Subject: Docket No.: 71-9282
Application for Model SPEC-300 Package
Supplement No. 1 to Application for NRC Certificate of Compliance, Revision (1),
Dated October 6, 1999

SUPPLEMENT NO. 1
to
Type B(U)-85 Transportation Package
Certificate of Compliance Application, Revision (1),
dated October 6, 1999
Model SPEC-300

UNLESS OTHERWISE SPECIFIED DIMENSIONS ARE IN INCHES TOLERANCES ARE		SOURCE PRODUCTION & EQUIPMENT CO., INC. 113 TEAL ST, ST ROSE, LA 70087	
NOMINAL		APPROVAL	DATE
DO NOT SCALE DRAWING	DRAWN RAM	6/22/99	GENERAL ARRANGEMENT, SPEC-300 EXPOSURE DEVICE
TREATMENT	CHECKED PW	6/28/99	SIZE DWG NO.
NONE	APPROVED RDO	6/28/99	C 19B000
FRESH	QA CLASS Q-R		SCALE: NTS M 00085203 SHEET 1 OF 8
NONE			REV 3

SOURCE PRODUCTION & EQUIPMENT CO INC 113 JEAL ST, ST ROSE LA 70067	SIZE DWG NO C 19B000	REV 3
APPROVED <i>RUP 11/1/99</i>	SCALE: 1/2	M 00085203 SHEET 5 OF 8

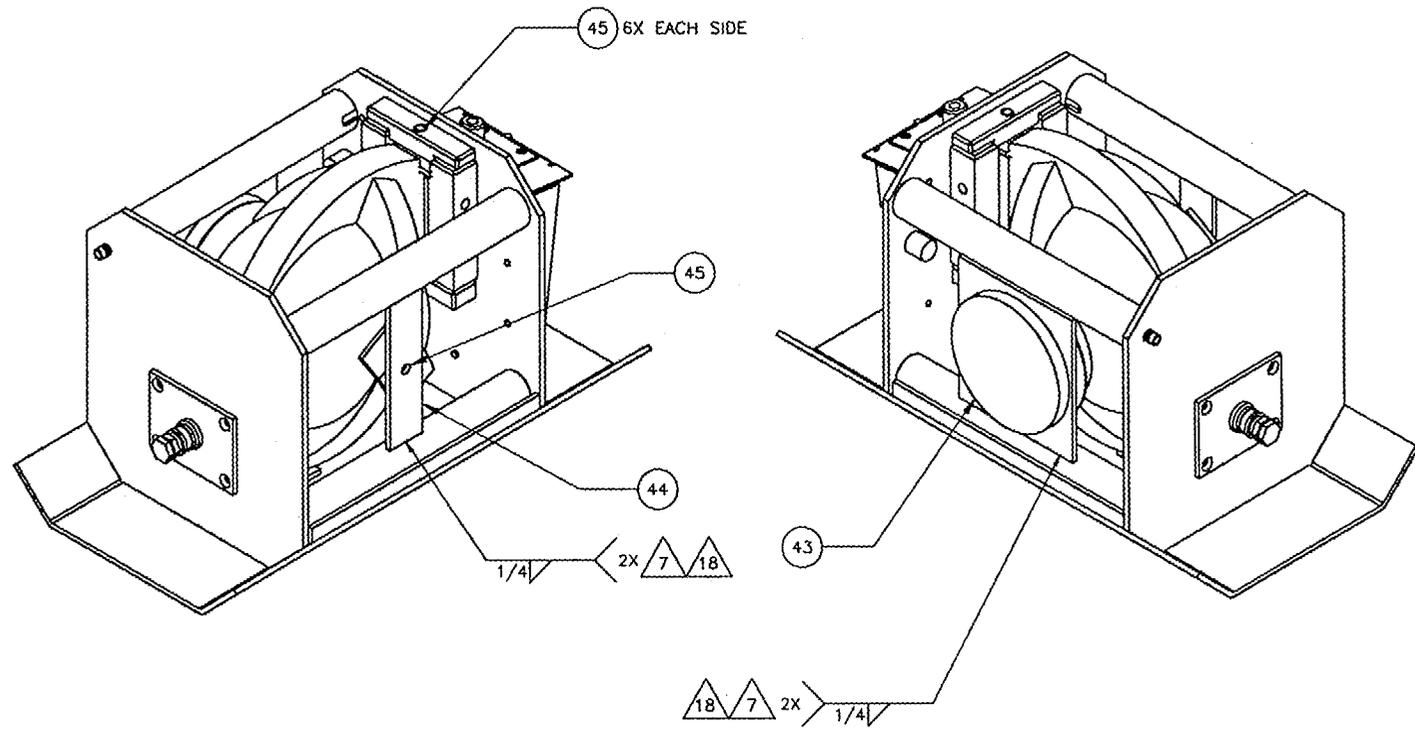
The information contained in this drawing can now also be found in drawing 19B000, revision 3, sheets 4 and 5.
